**BEST STREAM AND WETLAND RESTORATION PROJECT
MONITORING REPORT
MONITORING YEAR 4
FINAL**

DUPLIN COUNTY, NORTH CAROLINA
CONTRACT No. 004631 - PROJECT No. 95353
USACE Action ID No. 2012-01384 -NCDWR Project No. 13-0865

RE: Best Stream and Wetland Restoration Site: MY4 Monitoring Report (NCDMS ID 95353)

Listed below are comments provided by DMS on December 14, 2018 regarding the Best Stream and Wetland Restoration Site: Year 4 Monitoring Report and RES' responses.

2018 Best Site Groundwater Monitoring Gauge Hydrographs

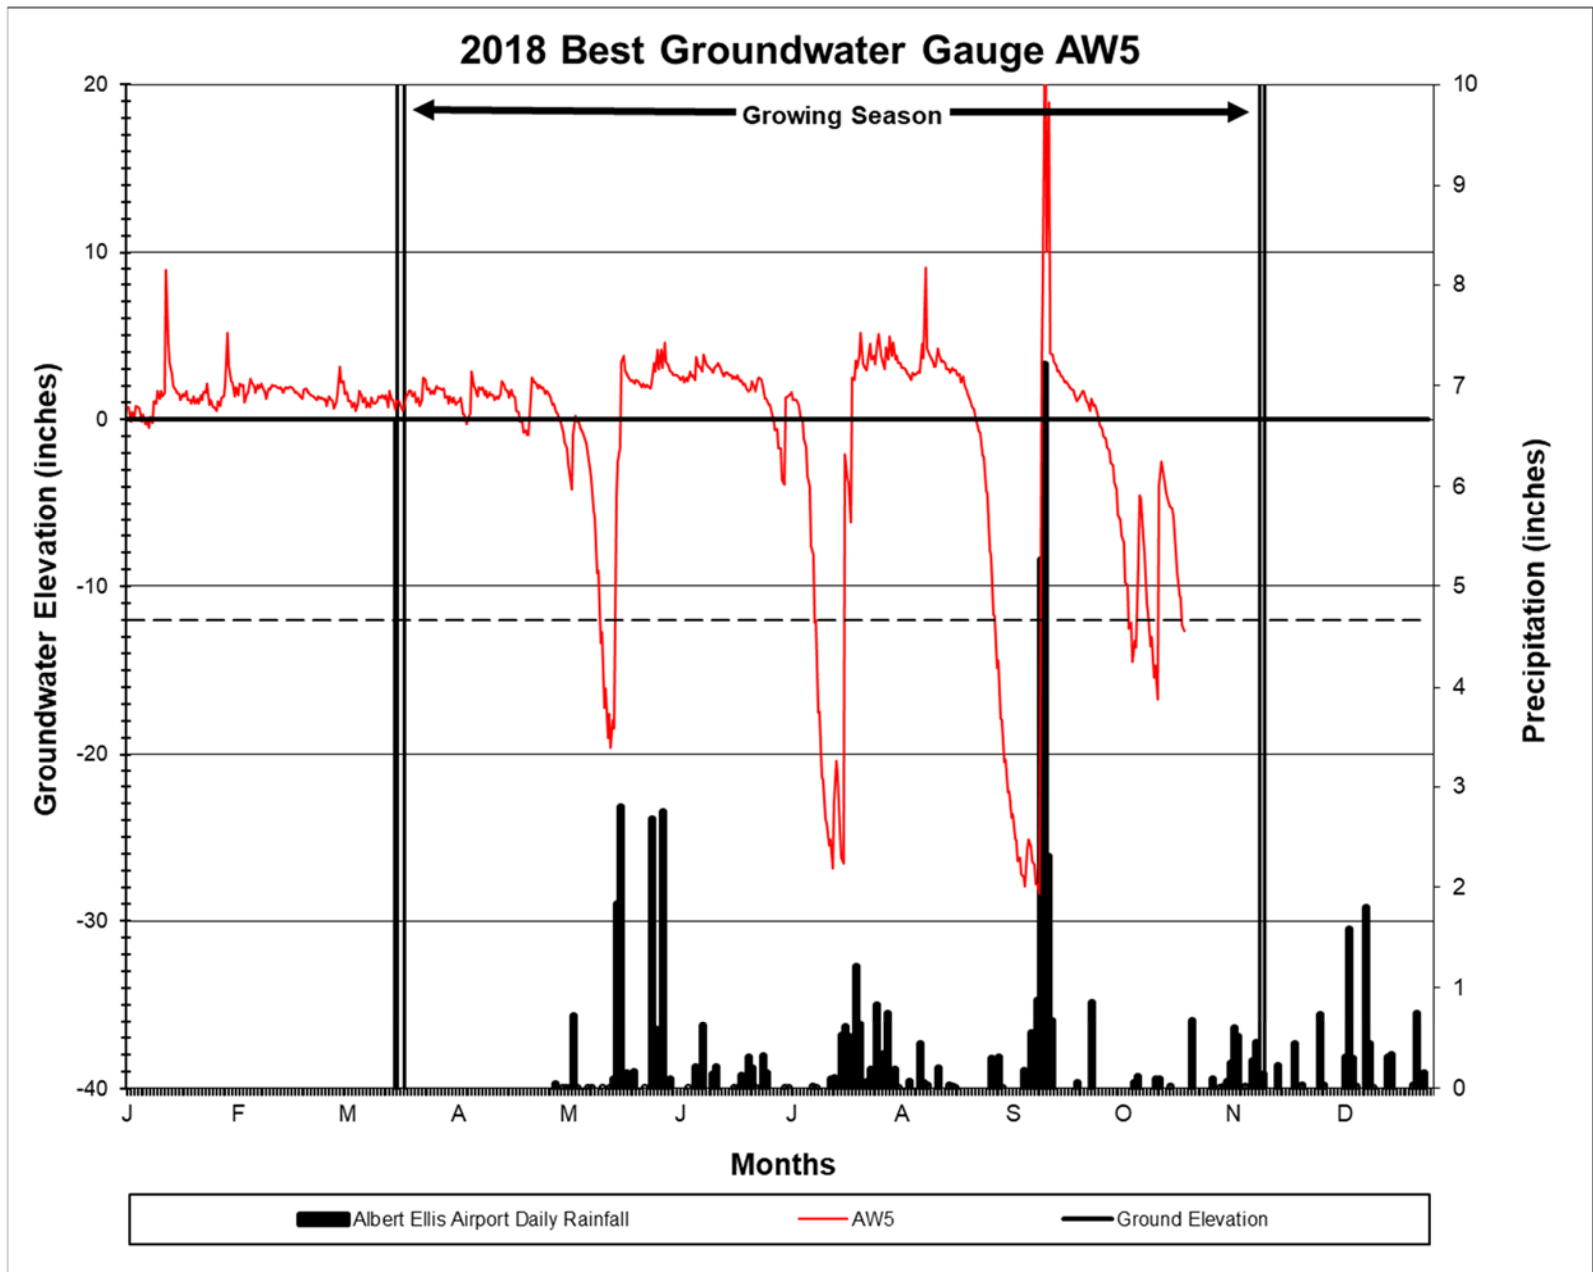
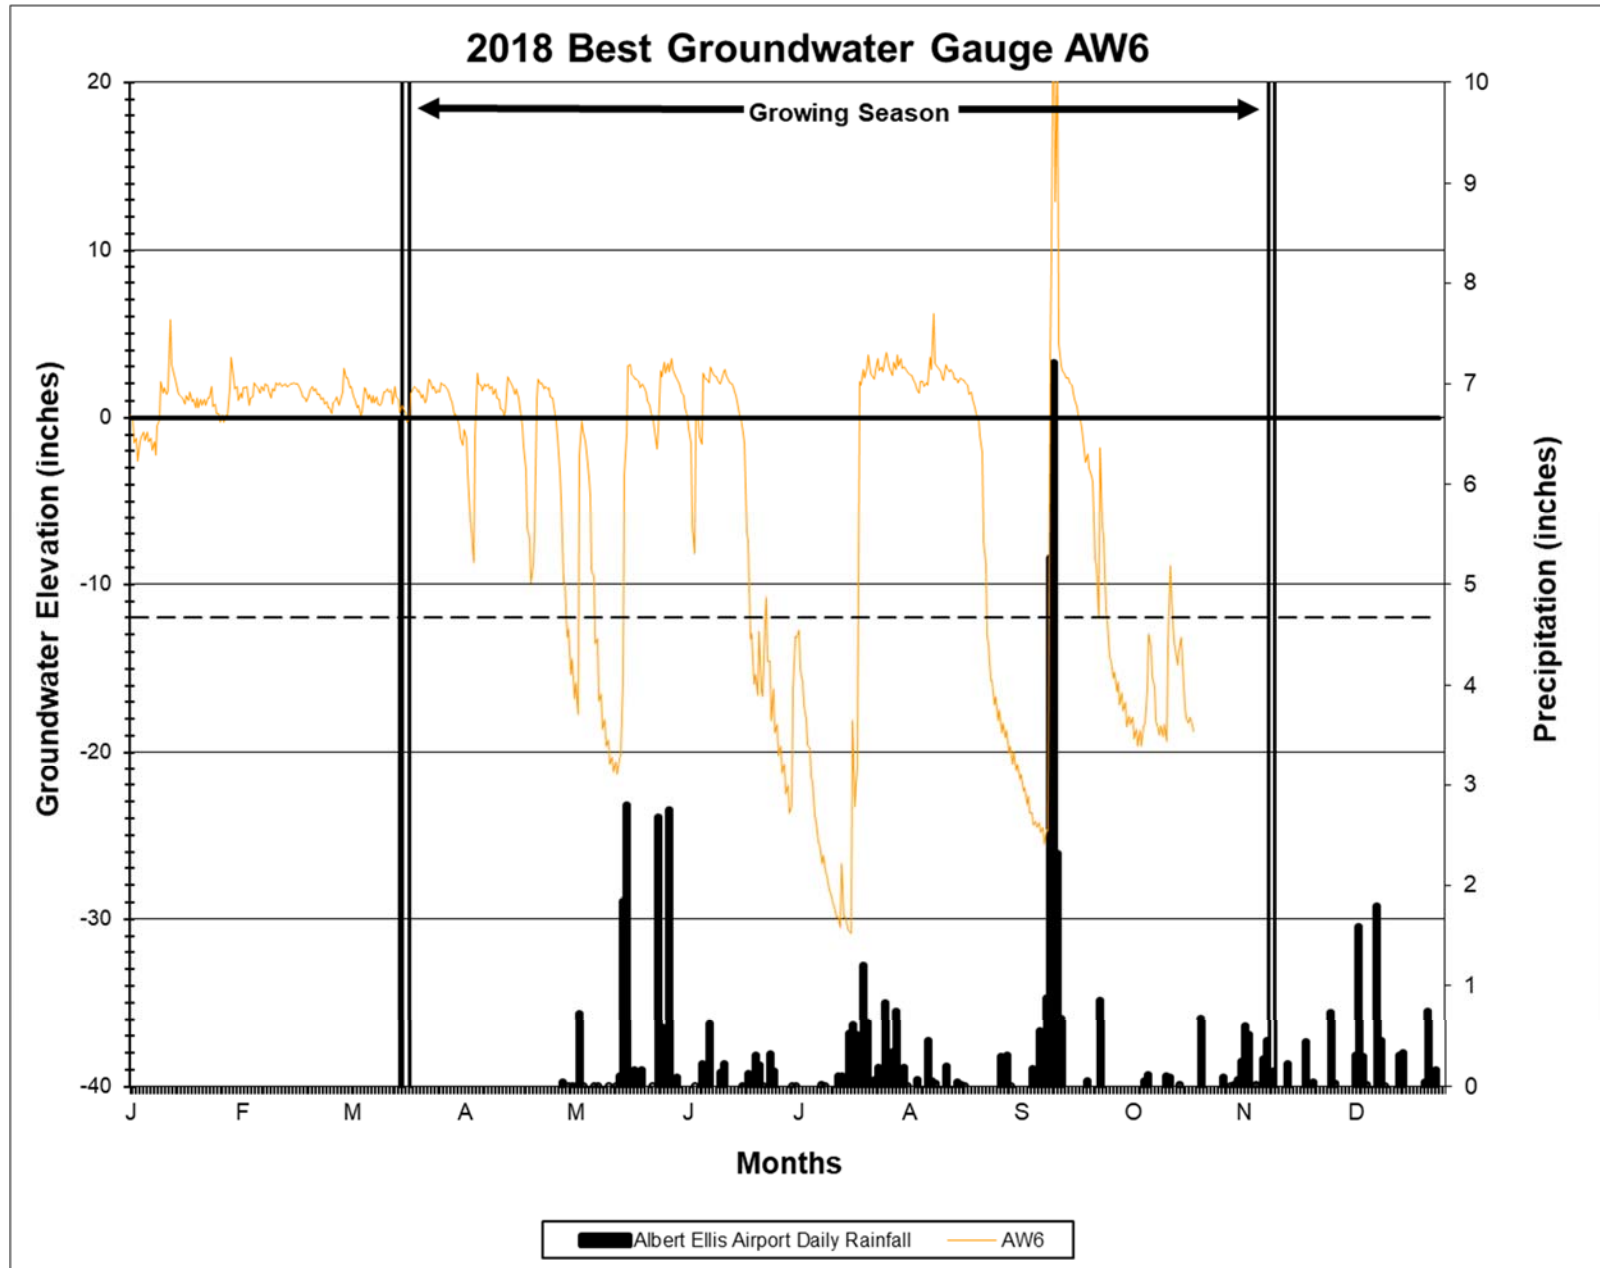
8. **Appendix E:**
2018 Groundwater Monitoring Gauge Hydrographs: In reviewing these hydrographs, it appears that the entire growing season was not observed for the wetland assessment/gauge data collection. Please explain why not.
[The wetland assessment/gauge data only represents 91% of the growing season because the last monitoring site visit for 2018 was October 24. Despite missing data from the last 22 days of the growing season, all wetland gauges met the success criteria.](#)
Verify rainfall data for September. Looks low based on impacts from Hurricane Florence.
[The Albert Ellis Airport rain gauge malfunctioned during Hurricane Florence. More accurate rain data from the Williamsdale Field Lab was used to supplement the Albert Ellis Airport rain data.](#)
